CHANGE ORDER 5

PROJECT:	HUMBOLDT COUNTY PROBATION BUILDING FIRE RECONSTRUCTION PROJECT 2002 Harrison Ave., Eureka, CA 95501 Project No. 170212	CHANGE ORDER NO:	5
CONTRACTOR:	Adams Commercial General Contracting, Inc. 217 E Street, Eureka, CA 95501 Ph. (707) 443-6000	Original Completion Date:	January 11, 2024
		Current Completion Date:	March 23, 2024
		Revised Completion Date:	April 26, 2024

CP No.	Description	N.F.L.	Cal. Days	Amount
26.0	Paint & Electrical Changes per LOI-10.1	X	0	\$1,966.62
28.0	Finish Between Lift & Walls-Floor per RFI-37		2	3,181.07

E200

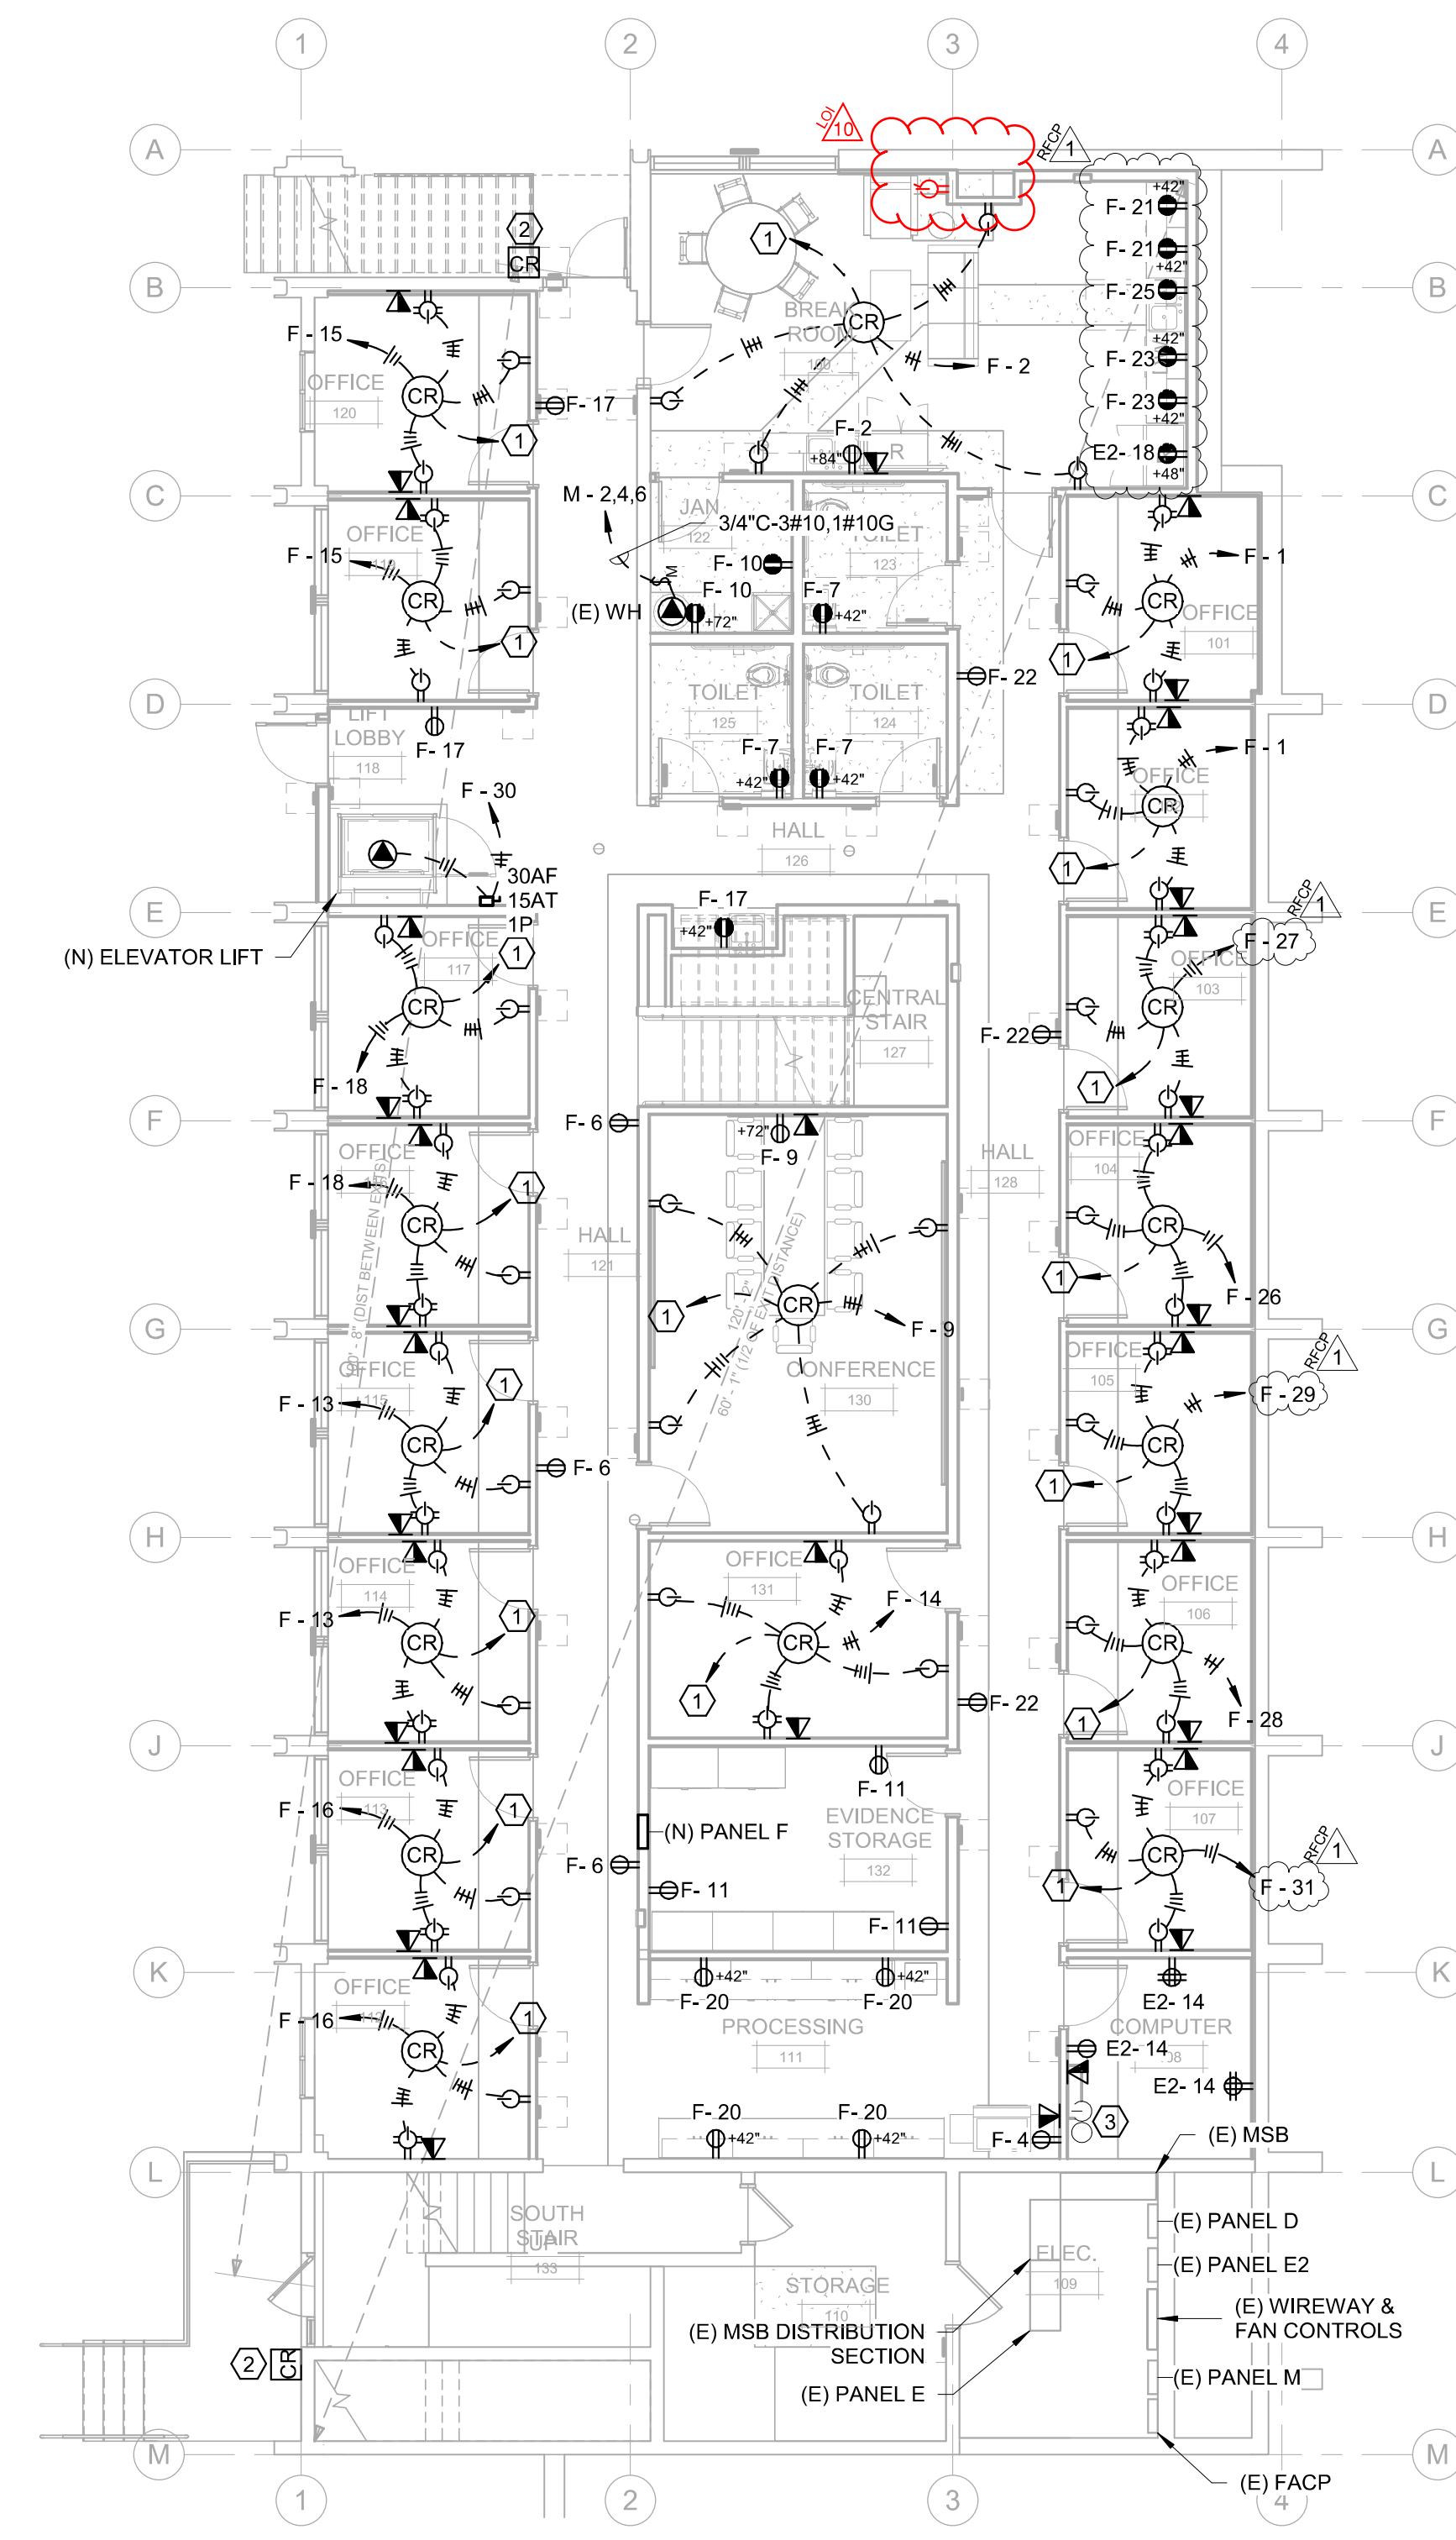
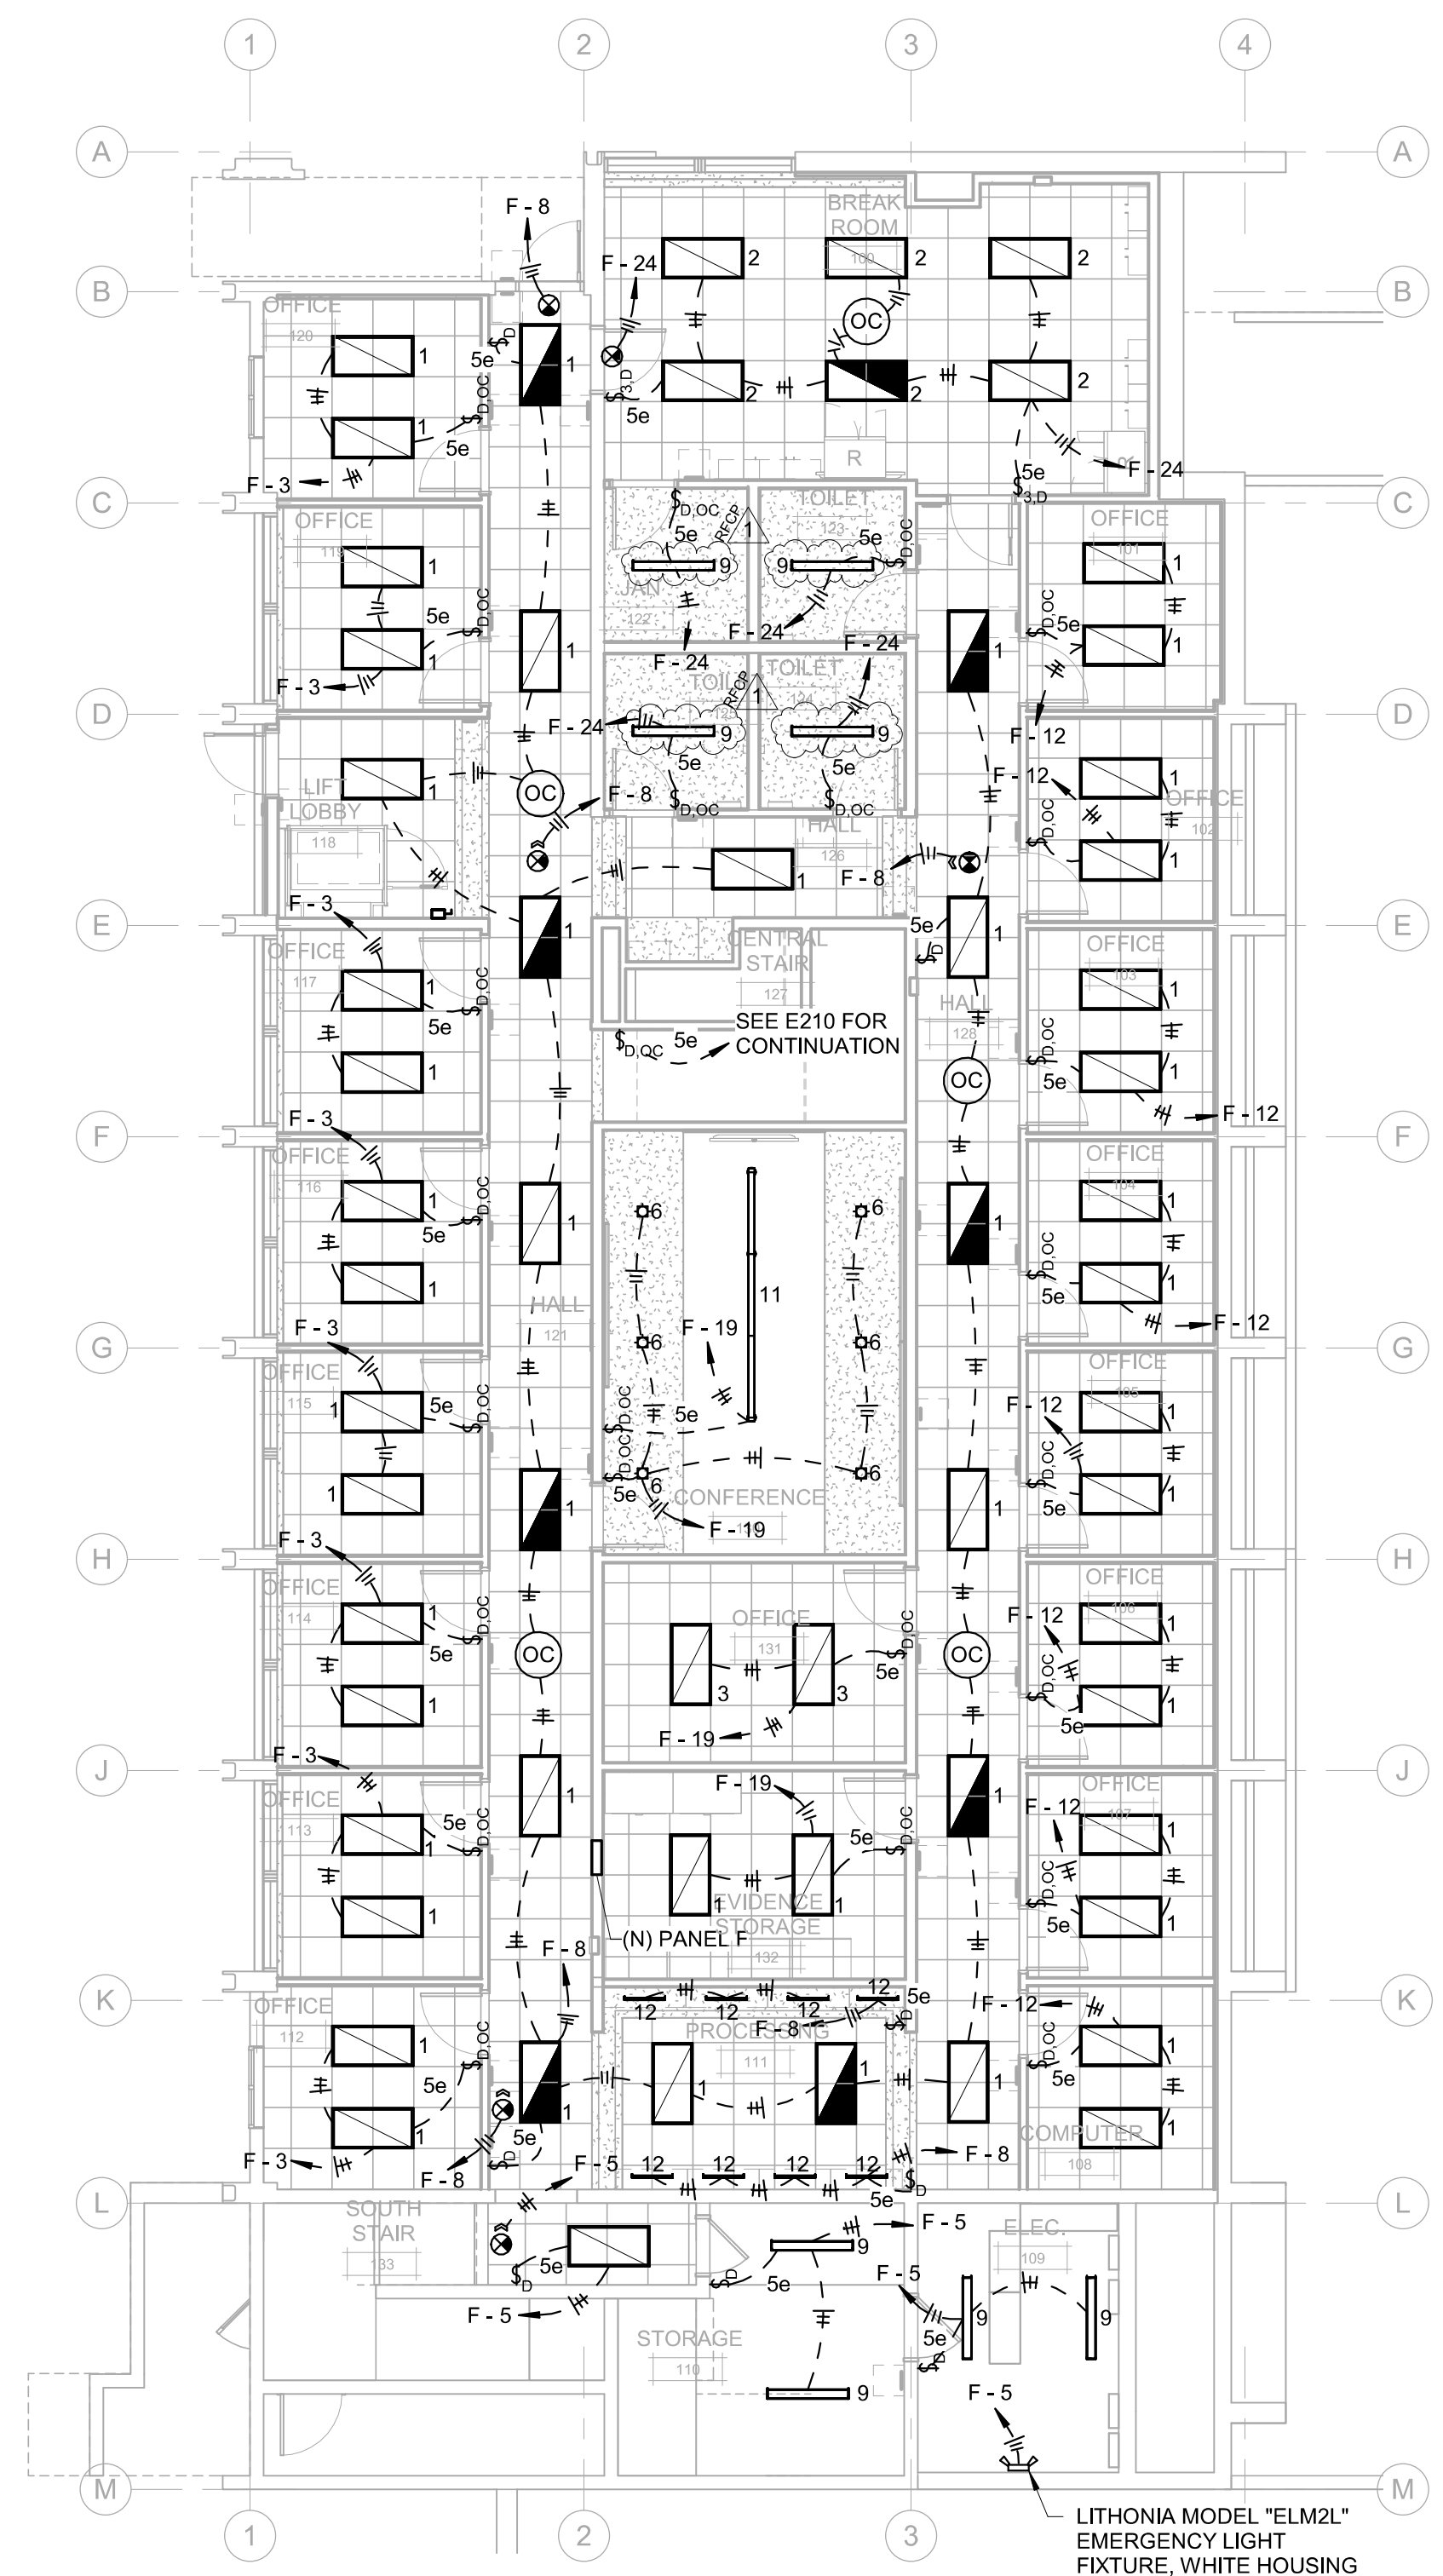
- Add a 120v outlet in Break Room 100 as indicated on attached drawing E200.
